Access Compliance Report

Public Rights-of-Way

Intersection ID: 10024974	Main Street: DIXIE_RIVER_RD	Cross Street: N/A	Location: S
ADA ID: A15FEA378071	Ramp Type: Perp	Initial Pass/Fail: Fail	Overall Compliance: No
Codes/Mitigation Info/Possible Solution		Field Measurements/Component Compliance	
Severity Score: 12.5

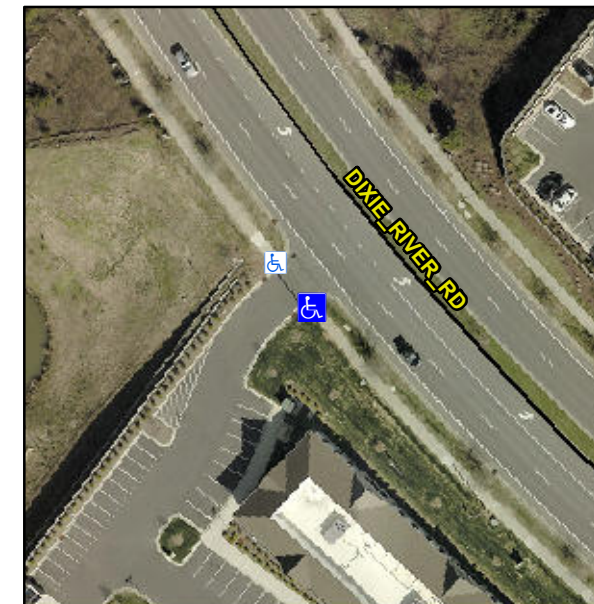
Not Found, R304.2.2

Compliance	Description	Data	Compliance	Description	Data
N/A	Ramp Length (in)	73.0	No	Ramp Slope (%)	9.0
Yes	Ramp Width (in)	48.0	Yes	Ramp XSlope (%)	1.1
N/A	Flare Type LT	N/A	N/A	Flare Type RT	N/A
N/A	Flare Slope LT (%)	N/A	N/A	Flare Slope RT (%)	N/A
N/A	Flare Traversable LT?	N/A	N/A	Flare Traversable RT?	N/A
N/A	Landing Length (in)	N/A	N/A	DWS Provided?	N/A
N/A	Landing Width (in)	N/A	N/A	DWS Contrast?	N/A
N/A	Landing Slope (%)	N/A	N/A	DWS Length (in)	N/A
N/A	Landing X Slope (%)	N/A	N/A	DWS Full Width?	N/A
N/A	Landing Curb? (Y/N)	N/A	N/A	DWS Offset (in)	N/A
N/A	Shared Landing?	N/A			
N/A	Gutter Ponding?	N/A	N/A	Gutter Slope (%)	N/A
N/A	Gutter Lip Ht (in)	N/A	N/A	Gutter X Slope (%)	N/A
N/A	Painted X Walk1?	No	N/A	Painted X Walk2?	N/A
	X Walk 1 Direction	To N		X Walk 2 Direction	N/A
N/A	X Walk 1 Width (in)	N/A	N/A	X Walk 2 Width (in)	N/A
	X Walk 1 Slope (%)	5.0		X Walk 2 Slope (%)	N/A
	X Walk 1 X Slope (%)	1.1		X Walk 2 X Slope (%)	N/A

Remove & Replace Entire Ramp.
